CONSTRUCTION DOCUMENTS
FALCON MEADOWS AT BENT GRASS FILING NO. 1
FOR
CHALLENGER COMMUNITIES, LLC
BENT GRASS MEADOWS DRIVE & MERIDIAN ROAD
FALCON, CO 80831 - EL PASO COUNTY

INTERSECTION DETAILS

BENT GRASS MEADOWS DR. & HENZLEE PLACE DETAIL GRADING

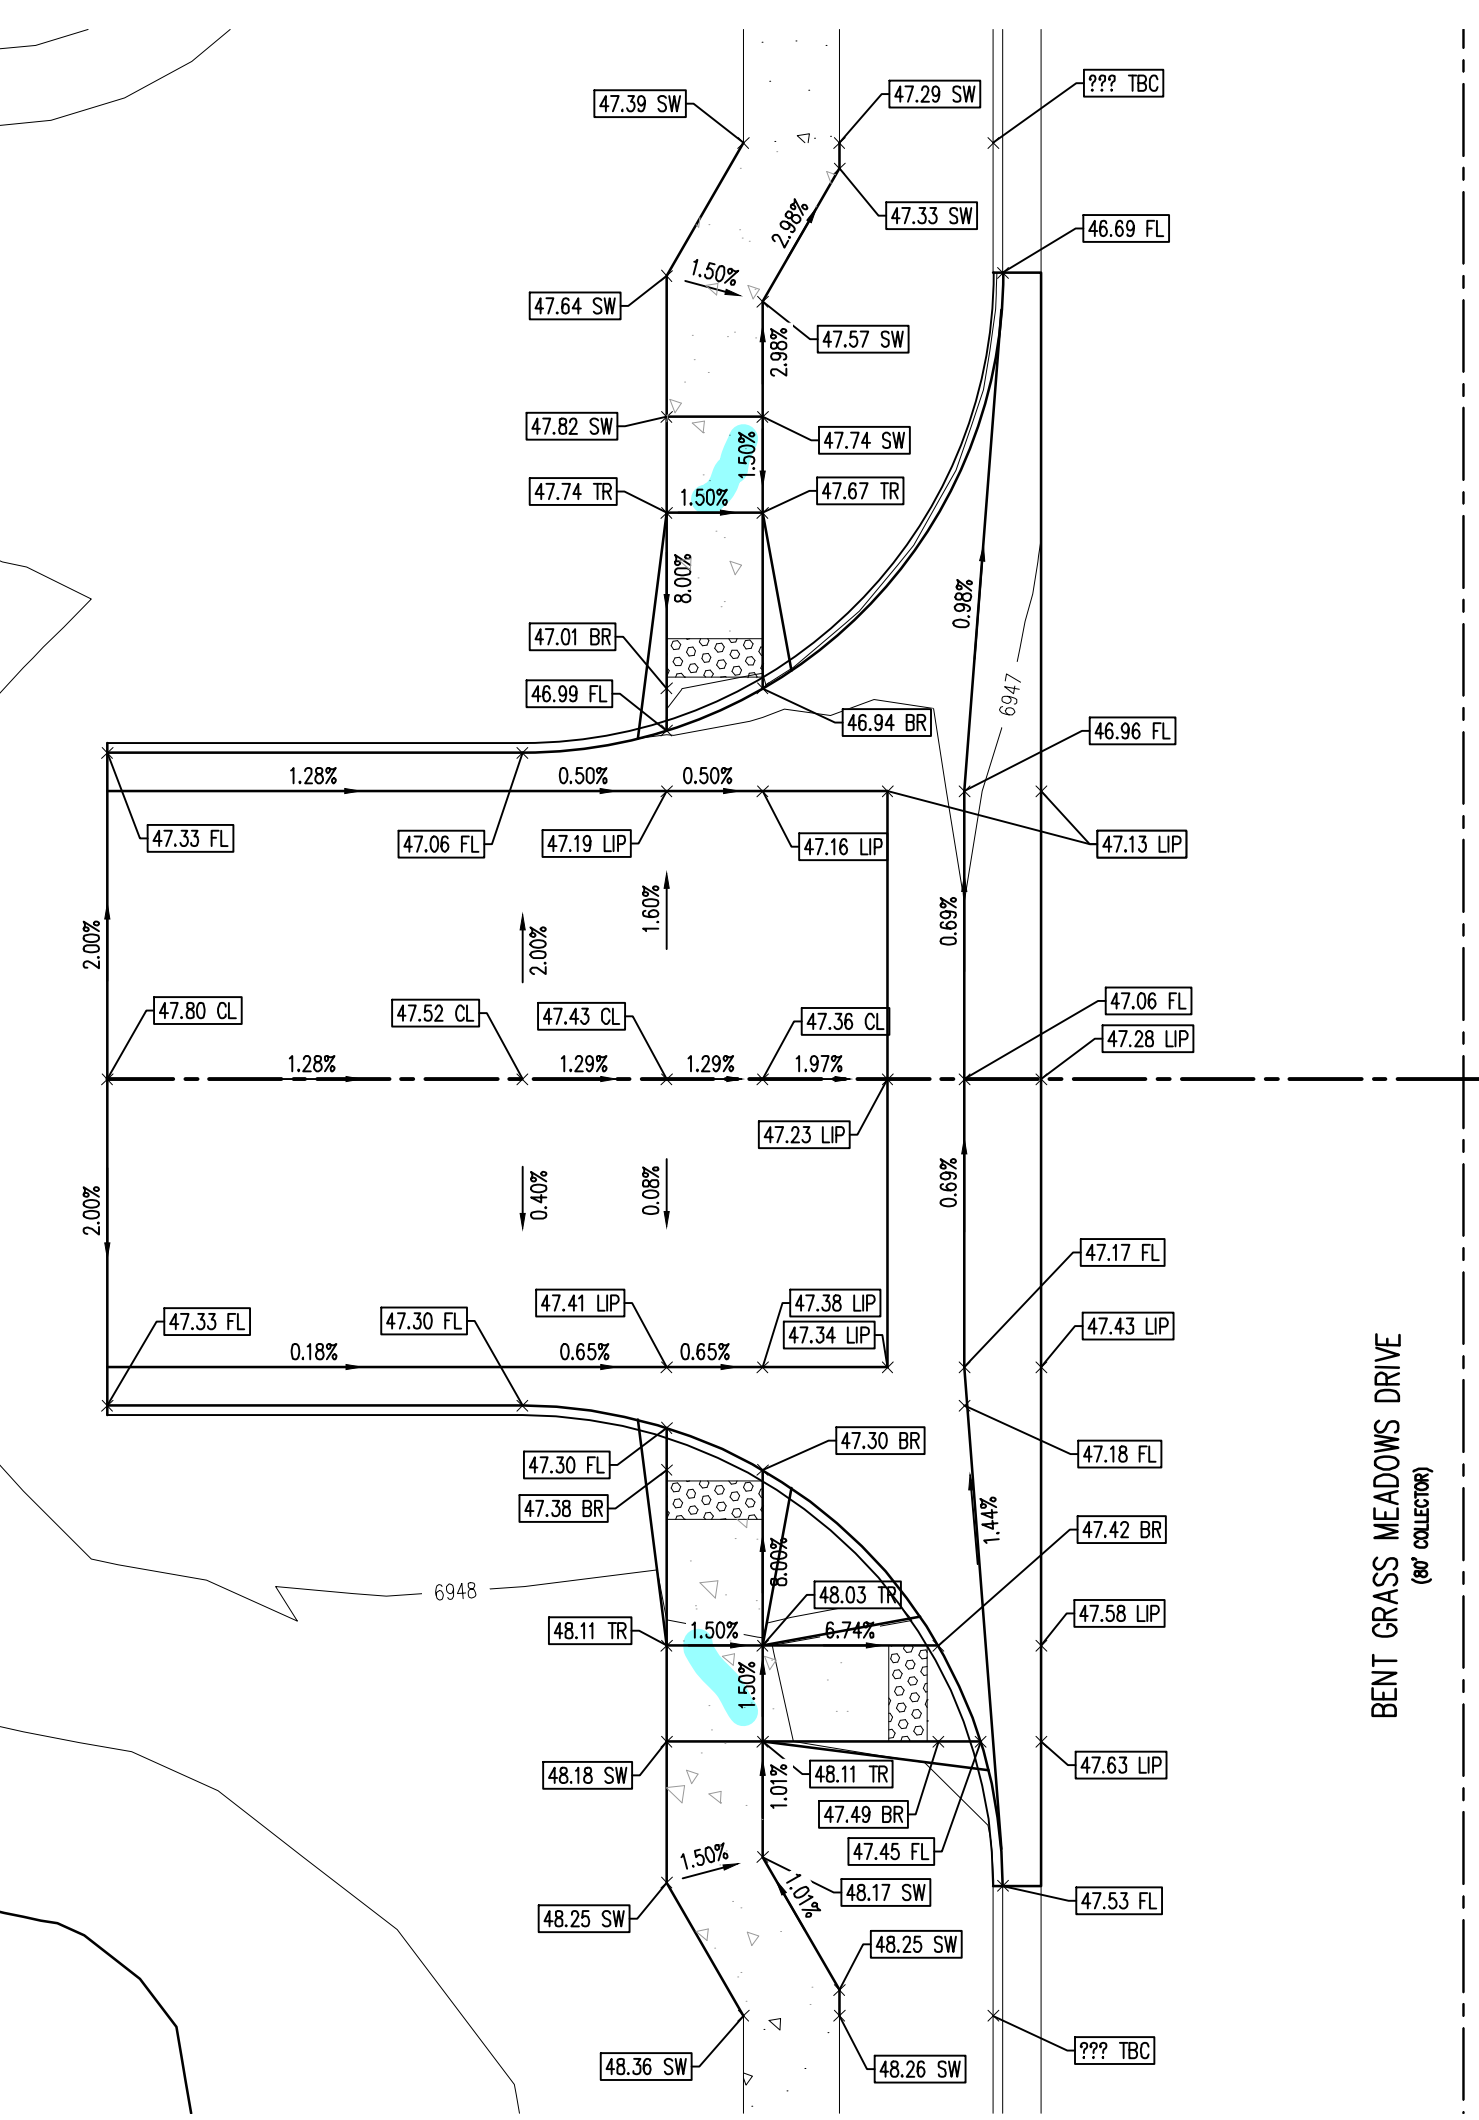
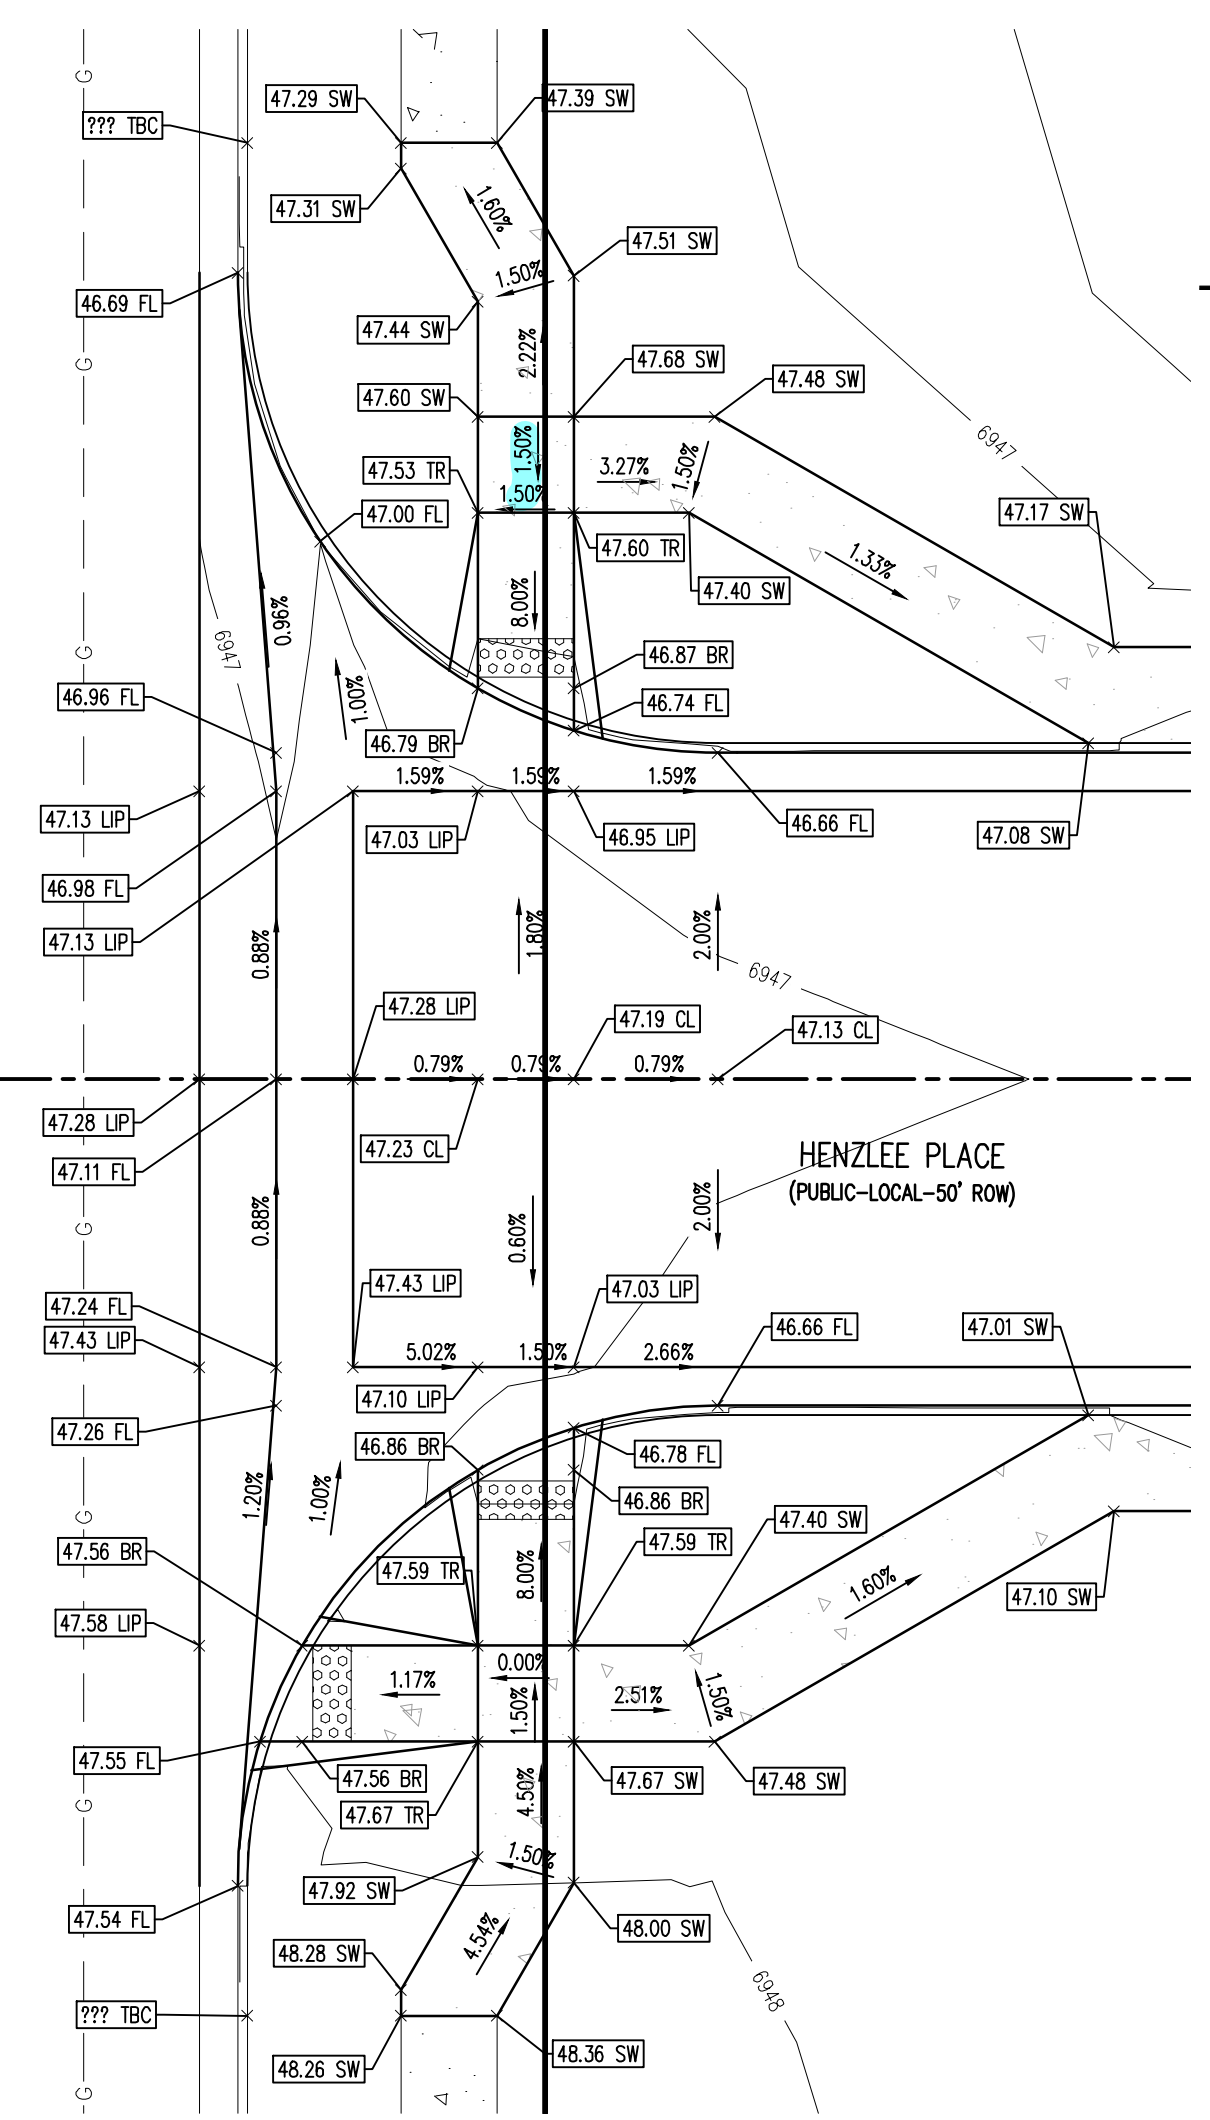
REVISED LOW POINTS AND CROSS SLOPES TO 1.4%
